Re: Two Significant Enhancements To Tyco's ESRP, Tyco Fire Products LP – Stanton Street Facility, Marinette, Wisconsin, WID 006 125 215

FIGURE 2C
 Remediation Sequence 2012
 Preliminary Basis of Design
 Tyco Fire Products Facility
 Marinette, WI

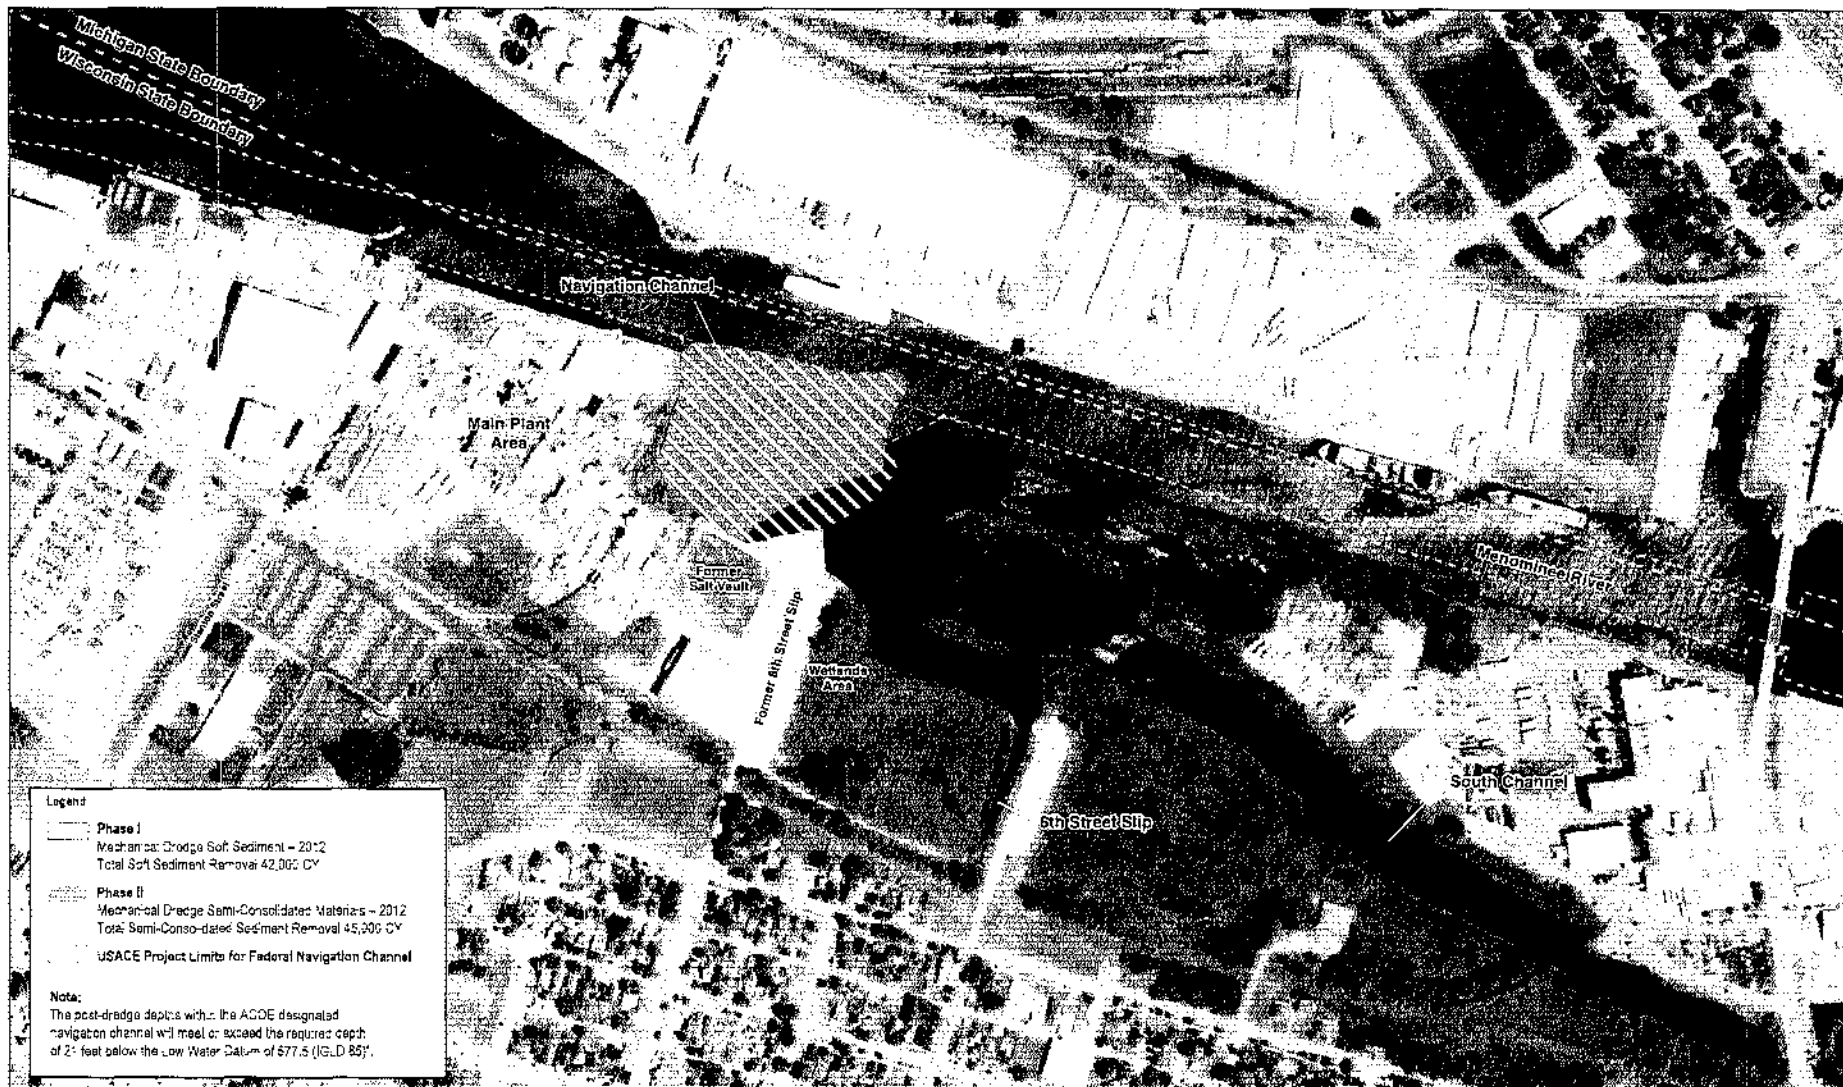
During the 2012 construction season, Tyco will dredge all soft and semi-consolidated sediment with concentrations of total arsenic exceeding 50 mg/kg in the entire federally designated navigation channel and in certain adjacent areas, as depicted in Attachment 1. *Accordingly, Tyco is no longer pursuing the U.S. Army Corp of Engineers ("ACOE") authorization that would be necessary to allow the in situ management -- chemical and physical isolation -- of contaminated semi-consolidated sediments in the designated navigation channel.* Therefore, other than during active dredging, the ESRP will not restrict anchoring or navigation in the navigation channel by

users such as Marinette Marine Corporation. At the completion of the 2012 field season, the depths in the ACOE designated navigation channel will be 21 feet or greater. To the west of the navigation channel depths will range from about 6 feet to 21 feet, depending on the depth of the contaminated semi-consolidated sediments. To the east the post-dredging depth will slope upward from the navigation channel (> 21 feet) to the existing sediment surface.
